*Appeal #8*

2021-2274-ZC

## ZONING STAFF REPORT

**Date:** October 5, 2021  
**Case No.:** 2021-2274-ZC  
**Posted:** October 8, 2021

P.U.D. CONCEPTUAL PLAN AND TENTATIVE SUBDIVISION PLAN  
 VIEUX CARRE  
 SECTION 46, T-7-S, R-11-E  
 ST TAMMANY PARISH, LA.

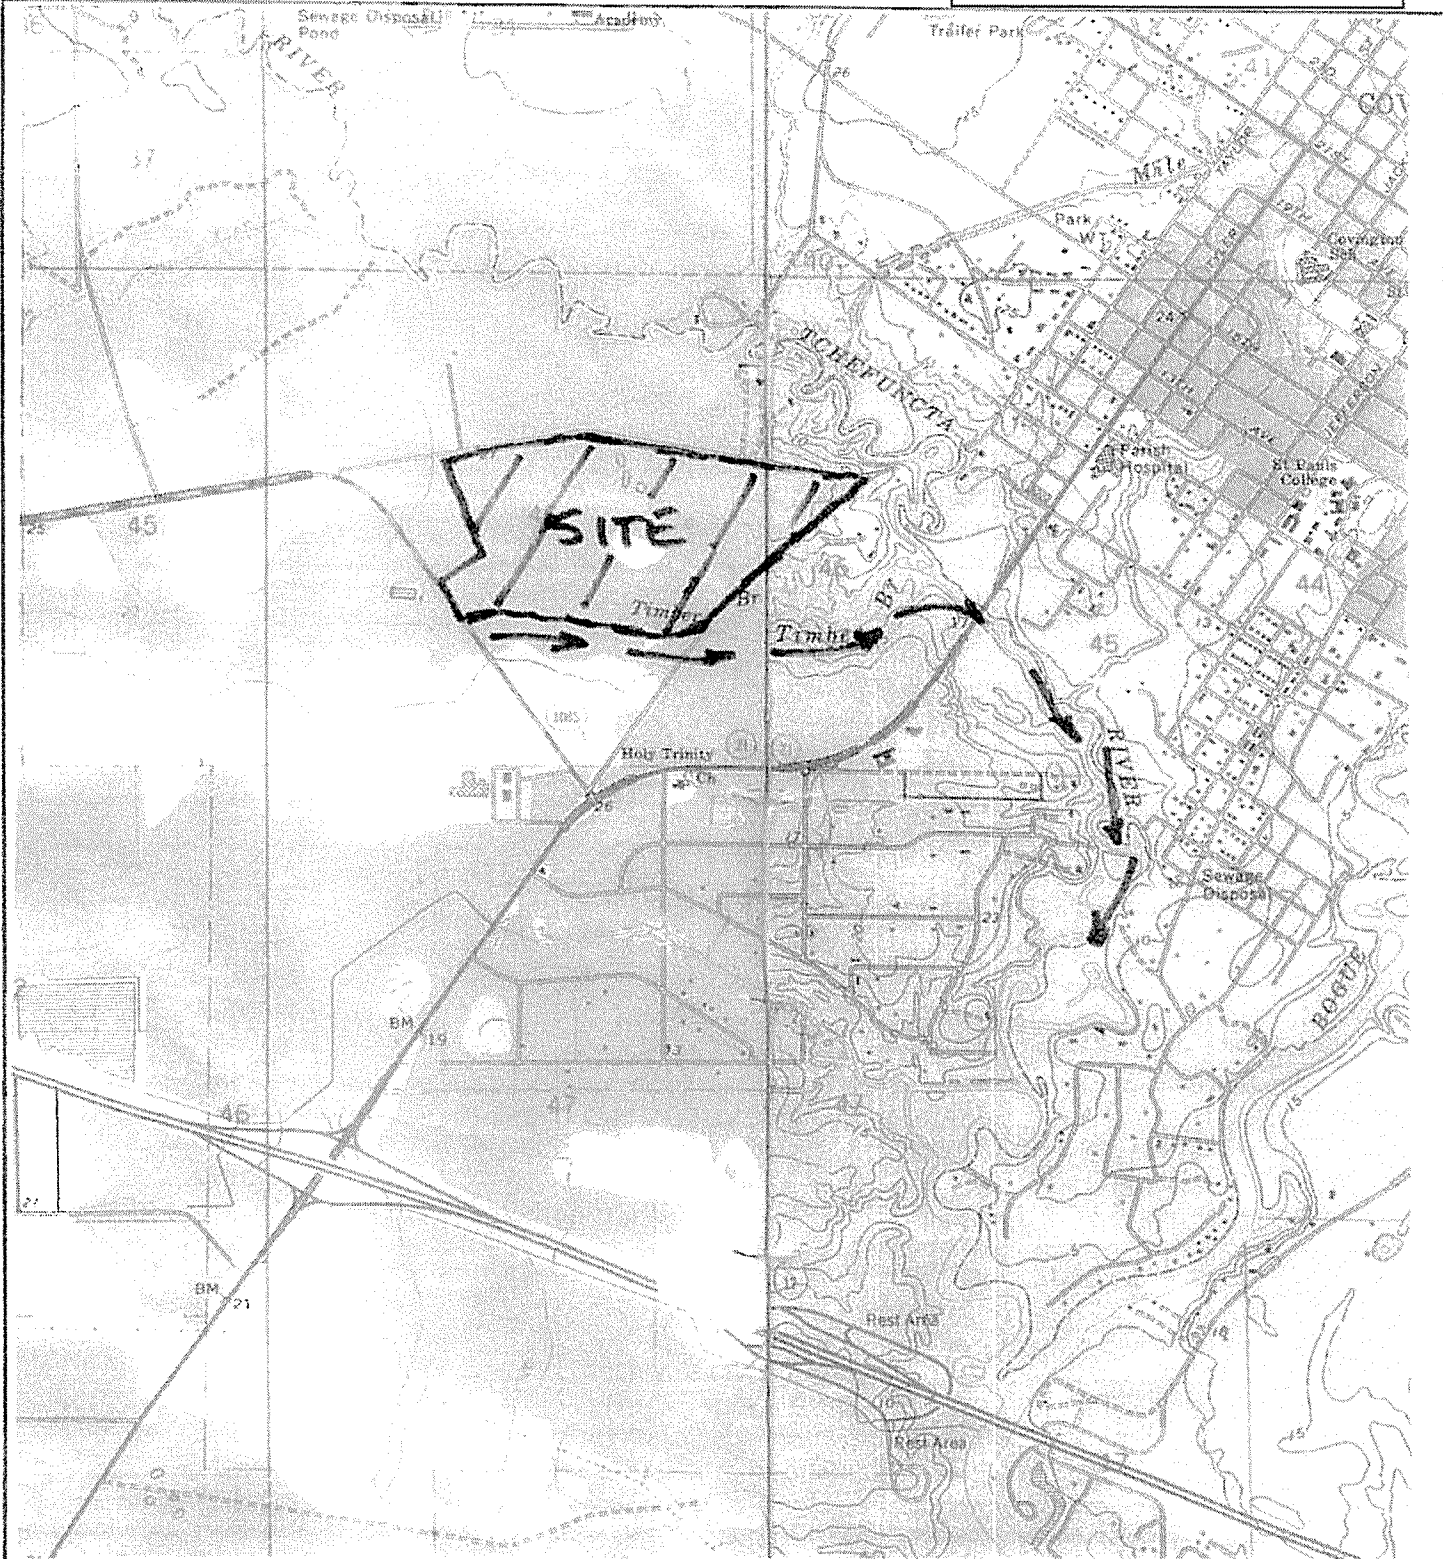
1. *Environmentally sensitive design that is of a higher quality than would be possible under the regulations otherwise applicable to the property.*
  - The applicant has provided wetland limits that include an approximation of 65 acres which accounts for a total of 41% of the PUD. If wetlands are to be developed, they should be done in a way that is in accordance with an environmentally friendly design including limiting land disturbance, protection of natural areas and habitats, and innovative and effective storm water management.

- The proposed PUD plan is providing 335 standard lots which are dimensioned at 60 ft. x 120 ft. and 80 garden home lots which are dimensioned at 50 ft. x 100 ft. – 120 ft. As submitted, there is no diversification of single-family housing types. The 14.87 acre “Planned Business Use Area” provides a mix of uses.

3. *Functional and beneficial uses of open space areas.*
  - The proposed PUD plan has allocated 10.66 acres of undeveloped greenspace to act as water access to Timber Branch. This access has no formal entry point and residents looking to use this recreational area will need to first traverse the 16.96-acre dry detention storage area. Staff recommends establishing a formal entry point for residents to actively use the space as well as the creation of a potential permeable parking area.

- The active recreational space that is proposed along the south side of the property includes nature trails. These trails appear to run in an east-west manner, in-between the dry stormwater area and the area dedicated to water access for the residents. These trails do not connect to the servitude which acts as the only formal access to these greenspaces and abruptly end at the edge of the site plan. The petitioners should reorient these walking paths to be inclusive of the entire useable portions of the greenspace as well as to provide access from the residential areas to Timber Branch.

4. *Preservation of natural features of a development site.*
  - The subject site is comprised of 41% of existing wetlands which serve an important function in flood mitigation. Removal of tree canopy and roots disturb the natural storage capacity of rainfall. Developing these wetlands may significantly increase runoff therefore exacerbating flooding and adversely impacting neighboring properties.

- The natural greenspace areas located along the southern perimeter of the proposed PUD should be placed into a conservation easement. This easement would permanently limit the use of the land and ensure the public benefit of open space is maintained.

5. *Creation of a safe and desirable living environment for residential areas characterized by a unified building and site development program.*
  - The proposed PUD plan should provide a formal access and extend the walking trail from the residential area to the greenspace which is provided along the south side of the plan. This addition will help to create a unified building and site development program.

- The proposed traffic circulation consists of one collector type road known as Armstrong Parkway which will service 263 home sites along the north side of the development and 152 home sites along the south side of the development. The road is bordered on either side with a 50 ft. buffer which will help to alleviate noise and increase safety to the abutting homesites. Staff recommends the applicant mimic the boulevard type entryway which is shown at the intersection of Bootlegger Road and Armstrong Parkway along the intersection of Bricker Road and Armstrong Parkway.

- The current configuration shows the proposed commercial area having access along Armstrong Parkway, which is the main roadway which provides access for the 415 proposed residential dwellings. As the permitted uses for the commercial area appear to provide uses consistent with large-scale office development, the applicant should increase the buffer in-between the commercially zoned portion of the PUD and the residential uses. Staff recommends the applicant ensure additional stress on current traffic situations are mitigated.

- The PUD plan is proposing to allocate 14.87 acres towards commercial and office uses. This request will allow for a diversification of uses within the development site. Staff has determined, however that the allowable site and structure provisions, including the floor area ratio and height regulations within the PBC-1 Planned Business Campus is not compatible with the surrounding residential uses along the northern side of Bricker Road.

1. Staff has concerns with the percentage of wetlands that exist within the subject property. Staff recommends the applicant work with their engineering team to ensure that if the wetlands are programed to be developed, they are done so in an environmentally friendly design including limiting land disturbance, protection of natural areas and habitats, and innovative and effective stormwater management. A Hydrologic Analysis, dated October 7, 2021, was submitted for this development by Kelly McHugh and Associates. The study has been reviewed by STP staff and appears to conform to STP Hydrologic Analysis and Fill Ordinances. The Hydrologic Analysis reports that the pre-development drainage flows mostly from the north along Bricker Road to the south to Timber Branch. The post-development condition is modeled to follow the same drainage pattern with a detention pond constructed north of Timber Branch and south of the proposed development. The Hydrologic Analysis demonstrates sufficient detention pond storage for the proposed impervious area. The proposed development is shown not adding fill material below the 15' contour, and creating additional flood plain storage volume between 13' and 15' by excavating a large portion of the existing natural ground between the elevation of 13' and 15'. The post-development condition includes a 100' undisturbed buffer between Timber Branch and the proposed detention pond. The approval of this Hydrological Analysis is conceptual at this time as no construction plans or detailed documentation has been provided; therefore, the Hydrological Analysis will be reviewed for conformance to the construction plans at Preliminary Approval where additional comments regarding the Hydrological Analysis may arise.

- ~~2. Staff has concerns with the water levels along the north-south portion of Bricker Road during storm events, where it intersects with the proposed Armstrong Parkway. Staff recommends the applicant work with their engineer to construct a bridge along this portion of Bricker Road to ensure the safety and feasibility of new traffic to the area.~~

The developer and his engineer agree that the low portion of Bricker Road where Timber Branch crosses it needs to be evaluated and improved as part of this project. The evaluation of this crossing will require additional modeling to accurately determine the correct improvements and elevations for the roadway and crossing in this location. This will be required as part of the developer's submittal for Preliminary Subdivision Approval.

A revised T.I.A. was submitted for this development by Kelly McHugh and Associates on 9/9/2021. The study has been reviewed by STP staff and appears to conform to STP Traffic Study Ordinances. STP has submitted the study to LADOTD in order for them to review the LA 21 @ Bootlegger Road intersection. LADOTD concurrence is needed regarding the "future" delays and queuing at this intersection before official approval of this T.I.A. can be granted. See the attached document containing the associated level of service tables for the proposed development.
